**NOTICE OF ADDENDUM
ADDENDUM NO. 2**

**CONTRACT NO. 7939
MADISON MUNICIPAL BUILDING - RENOVATION**

This addendum is issued to modify, explain or correct the original Drawings, Specifications, or Contract Documents and is hereby made a part of the contract documents.

WINDOW DETAILS
 IAW-11, IAW-17
EXHIBIT E
A652

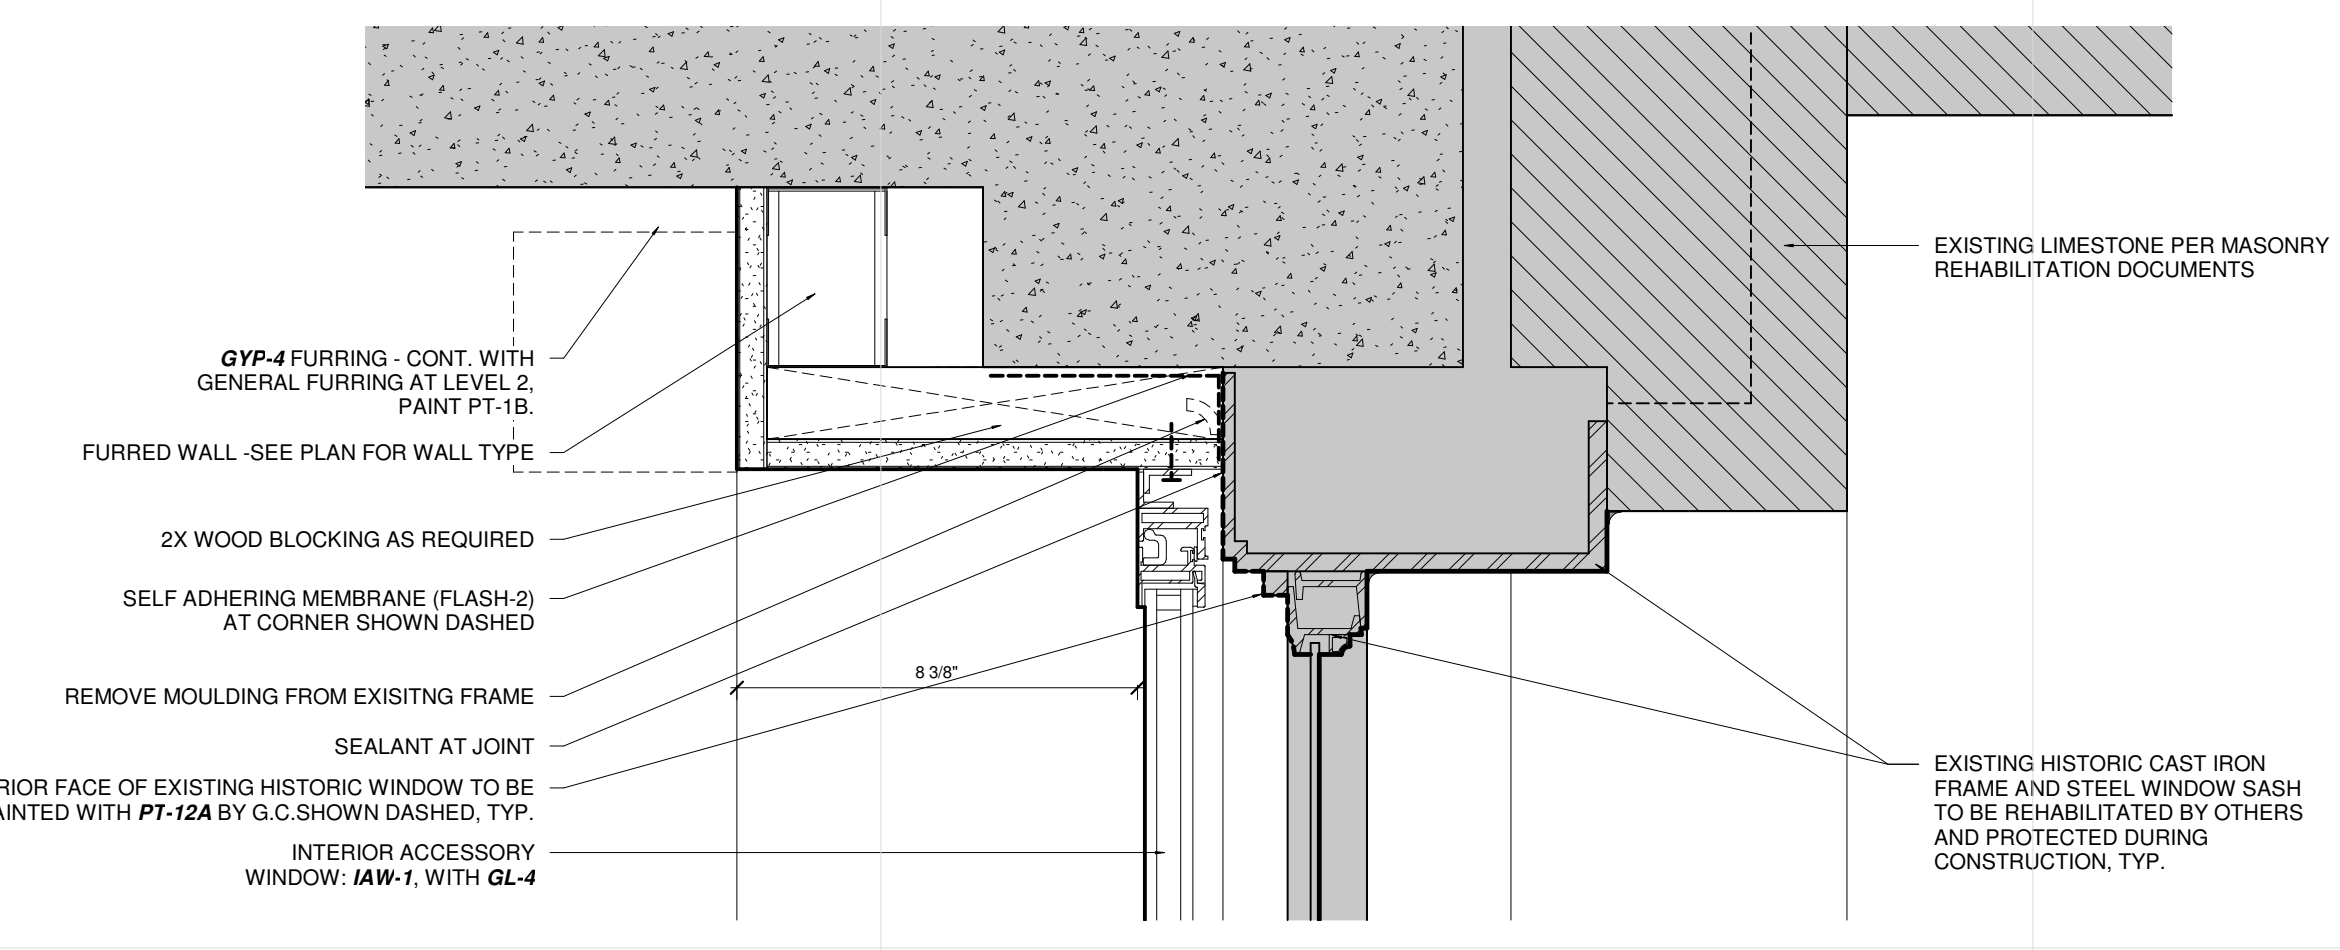
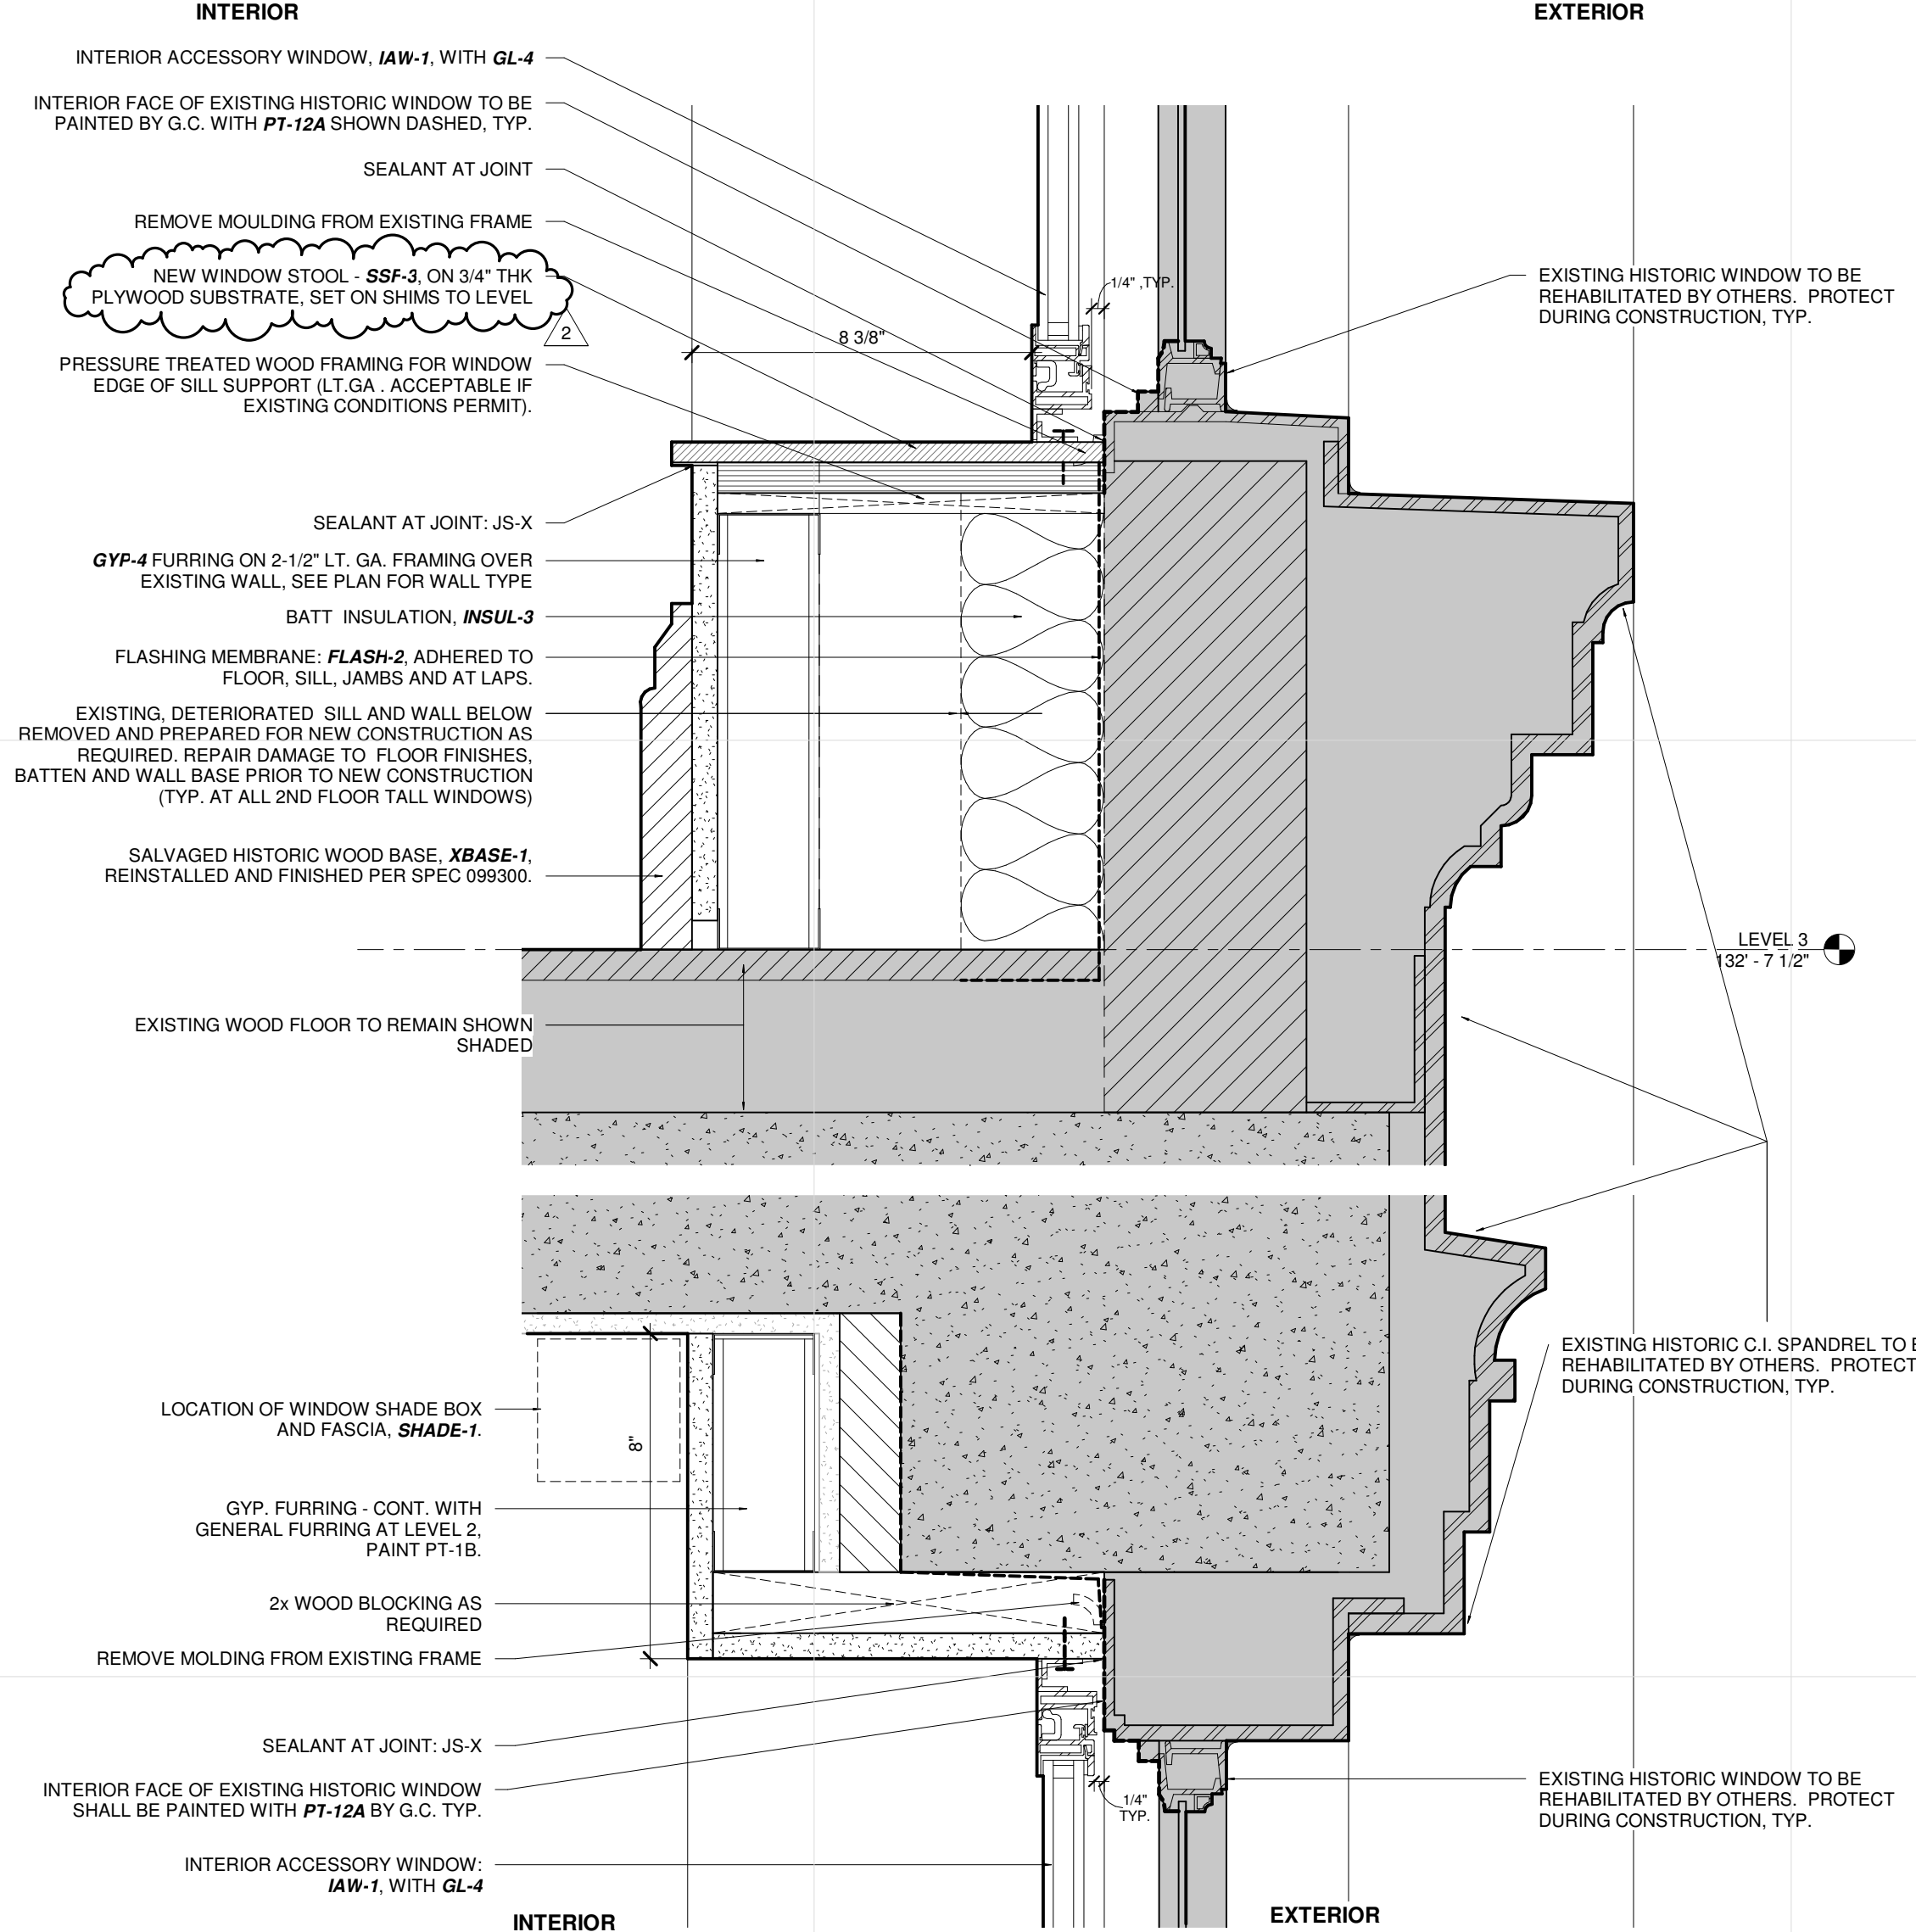
4. Details A620 through A624, and A651 through A654. Due to durability and cost concerns regarding the new metal window stools, these have been changed from MTL-3 to solid surface material SSF-3.
5. BE001. Amend general note 10 on sheet BE001 (drawing); Add language to general note 16 on sheet BE001 (drawing)
6. BE219. Revised stone numbers
7. BE338. See Clarifications Section below
8. BE356. See Clarifications Section Below
9. BE356.1. See Clarifications Section Below
10. BE356.2. See Clarifications Section Below
11. S101. See Structural Memo Attached.
12. S102. See Structural Memo Attached.
13. S103. See Structural Memo Attached.
14. S104. See Structural Memo Attached.
15. S190. See Structural Memo Attached.
16. S201. See Structural Memo Attached.
17. S302. See Structural Memo Attached.
18. S304. See Structural Memo Attached.
19. E300. See MEP Memo Attached.
